Project	IEEE 802.16 Broadband Wireless Access Working Group < http://ieee802.org/16 >	
Title	Support of legacy terminals in a 16m TDD system with four switching points	
Date Submitted	2008-05-12	
Source(s)	Per Ernström, Per-Erik Östling Ericsson AB SE-164 80 Stockholm, Sweden Kevin Power, Sunil Vadgama Fujitsu Middlesex, UK	E-mail: Per.Ernstrom@ericsson.com, Per-Erik.Ostling@ericsson.com Kevin.power@uk.fujitsu.com sunil.vadgama@uk.fujitsu.com
Re:	The call for contributions on “The entire content of IEEE 802.16m-08/003r1” (Frame structure)	
Abstract	Multiple sections of the documents contain text proposals in support of comment submitted separately on the proposed frame structure baseline content in document C802.16m-08/118r1.	
Purpose	Propose text changes to the SDD in support of a comment to IEEE 802.16m-08/003r1 (SDD) submitted separately	
Notice	<i>This document does not represent the agreed views of the IEEE 802.16 Working Group or any of its subgroups. It represents only the views of the participants listed in the “Source(s)” field above. It is offered as a basis for discussion. It is not binding on the contributor(s), who reserve(s) the right to add, amend or withdraw materia

[Figure X Time zones in a TDD system with four switching points per radio frame.](#)

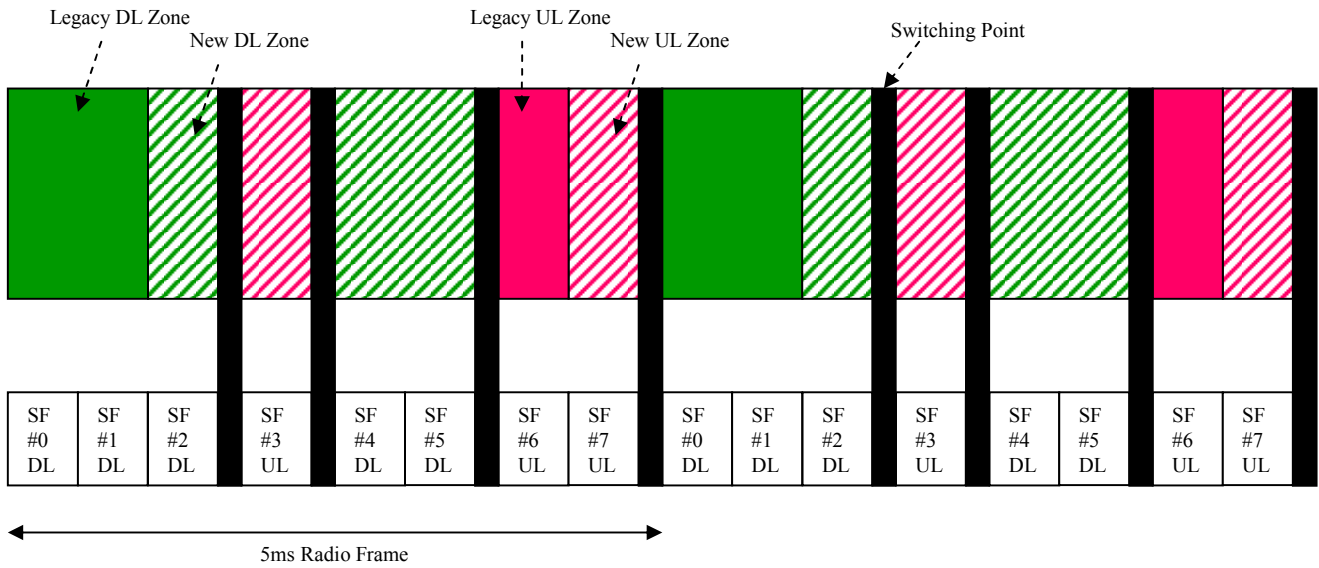
In the current SDD it is, however, not illustrated how a legacy terminal is supported in a 16m system with four switching points. Here we propose to include a figure and associated text to do that.

~~In a mixed deployment,~~ The allocation of time zones in the TDD duplex mode shall be as shown in Figure 13 [and Figure X for the two and four switching point case respectively](#). The duration of the zones may vary. Every frame shall start with a preamble and the MAP followed by legacy DL zone since legacy terminals/relays expect 802.16e zones in this region. In the case of coexistence, the UL portion shall start with legacy UL zone since legacy BS/terminals/relays expect 802.16e UL control information be sent in this region. [Here the coexistence is defined as a deployment where legacy and new BSs co-exist on the same frequency band and in the same or neighboring geographical areas and in this case, four switching points should not be used.](#) In a green-field deployment, the legacy zones can be removed.
